Item ID: D407-667-105TRN

Item Name: Crosstube Turning Detail

DART AEROSPACE LTD		Work Order:	99474
Description: Crosstube Assembly		Part Number:	D407-667-145
Inspection Dwg: D407-667-145 Rev: C		Page 1 of 2

DRAWING NO. D407-667-145	TITLE CROSSTUBE ASS'Y (407 HIGH FWD)	REV. C	DART AEROSPACE LTD ENGINEERING ORDER		D.E.O. NO. D407-667-145-C-1	SHEET NO. SHEET 1 OF 1	SCALE NTS
DRAWN <i>qp</i>	CHECKED <i>ASS</i>	MFG. APPR. <i>IB</i>	APPROVED <i>WD</i>		DE APPR. <i>#</i>		
DATE 11.07.15	DATE 11.07.22	DATE 11.07.22	DATE 11/07/22		DATE 11.07.21

DETAIL P
BONDING STRAP INSTALLATION 2 PL

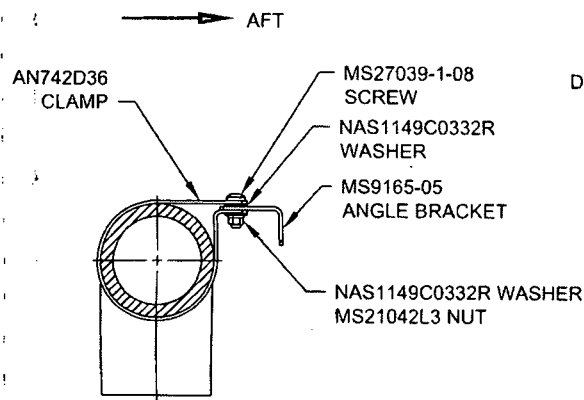
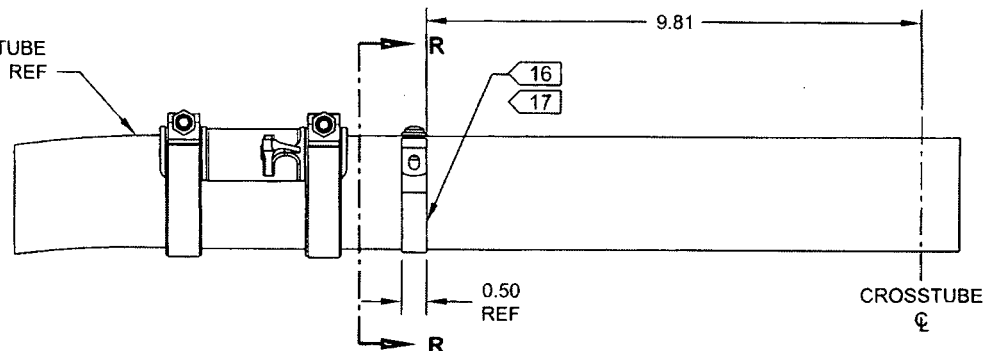
ADD ELECTRICAL GROUNDING STRAP

ITEM	QTY -145	PART NUMBER	DESCRIPTION
1	X	D407-667-145	CROSSTUBE ASSEMBLY (407 HIGH FWD)
10	2	AN742D36	CLAMP
11	2	MS9165-05	ANGLE BRACKET
12	2	MS21042L3	NUT (OR MS21042-3)
13	2	MS27039-1-08	SCREW
14	4	NAS1149C0332R	WASHER (OR AN960C10L)

- 16) MASK AREA UNDER CLAMP PRIOR TO PAINTING
- 17) SEAL EDGES WHERE AN742D36 CLAMP MEETS WITH THE CROSSTUBE USING SIKAFLEX-241/-291 OR MIL-S-8802 CLASS B2 OR PROSEAL 890 SEALANT
- 18) PERFORM RESISTANCE CHECK TO ENSURE MAX RESISTANCE IS 10 MILLIOHMS
